Permit of Authorization to Construct an On-Site Sewage Facility Permit Valid For One Year From Date Issued

Permit Number: 118785

1604 PONDEROSA DR NEW BRAUNFELS, TX 78132

Application for Permit for Authorization to Construct an On-Site Sewage Facility (OSSF)

OWNER: RONALD LEE & LANELL SHAW EJS III STREET ADDRESS: 1604 PONDEROSA DRIVE UNIT/SECTION/PHASE: BLOCK: SATTLER ESTATES 22 & 22A PREPARED BY GREG W. JOHNSON, P.E. F#002585 1"=40" 5/15/2025

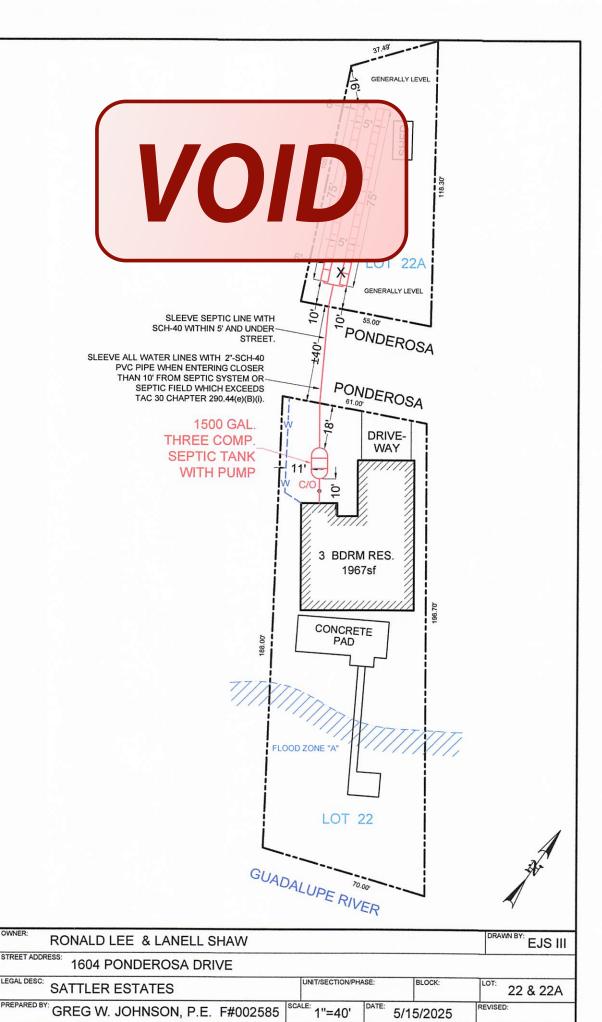
A copy of the Permit to Construct for the referenced permit submittal is attached. Be advsied that a Utility Road Crossing Permit will be required prior to installation of the sewer line crossing under the road. Coordination will also need to be made with Texas Water Company regarding the crossing of their easement with the sewer line.

Please provide verification from Texas Water Company on permission to cross their easement with the sewer supply line, or if any special coordination with them for said crossing is required.

- 1. Indicate the origin of the water supply line. Are there any public water lines at the street within 10 ft. of the sewer line?
- 2. Be advised that after the permit to construct has been issued an approved Utility Road Crossing Permit will be required prior to installation of the sewer line crossing under the road.
- 3. Revise as needed and resubmit.

Attached is the septic drawing showing the public water line crossings and the crossing information Texas Water Company will require from Chapter 290.44 (II)

Sewer line will be bored under the road and cross the public waterlines in accordance with this rule.

REVISED

(II) ALL SECTIONS OF WASTEWATER MAIN OR LATERAL WITHIN NINE FEET HORIZONTALLY OF THE WATERLINE SHALL BE ENCASED IN AN 18-FOOT (OR LONGER) SECTION OF PIPE. FLEXIBLE ENCASING PIPE SHALL HAVE A MINIMUM PIPE SIFFNESS OF 115 PSI AT 5.0% DEFLECTION. THE ENCASING PIPE SHALL BE CENTERED ON THE WATERLINE AND SHALL BE AT LEAST TWO NOMINAL PIPE DIAMETERS LARGER THAN THE WASTERWATER MAIN OR LATERAL. THE SPACE AROUND THE CARRIER PIPE SHALL BE SUPPORTED AT FIVE FOOT (OR LESS) INTERVALS WITH SPACERS OR BE FILLED TO THE SPRINGLINE WITH WASHED SAND, EACH END OF THE CASING SHALL BE SEALED WITH WATERTIGHT NON-SHRINK CEMENT GROUT OR A MANUFACTURED WATERTIGHT SEAL. AN ABSOLUTE MINIMUM SEPARATION DISTANCE OF SIX INCHES BETWEEN THE ENCASEMENT PIPE AND THE WATERLINE SHALL BE PROVIDED. THE WASTEWATER LINE SHALL BE LOCATED BELOW THE WATERLINE.

37.49 NOTE: GENERALLY LEVEL **EXISTING SEPTIC** TANK TO BE PUMPED, CRUSHED SHED AND BACK FILLED. EXISTING SEPTIC SYSTEM TO BE ABANDONED SLEEVE SEPTIC LINE WITH LOT 22A SCH-40 WITHIN 5' AND UNDER-GENERALLY LEVEL STREET. 0 55.00 SLEEVE ALL WASTEWATER LINES WITH 2"-SCH-40 PVC PIPE WHEN ENTERING 4" WATER MAIN CLOSER THAN 10' FROM SEPTIC SYSTEM-9 OR SEPTIC FIELD WHICH MEETS PONDEROSA TAC 30 CHAPTER 290.44(II). 2" WATER MAIN
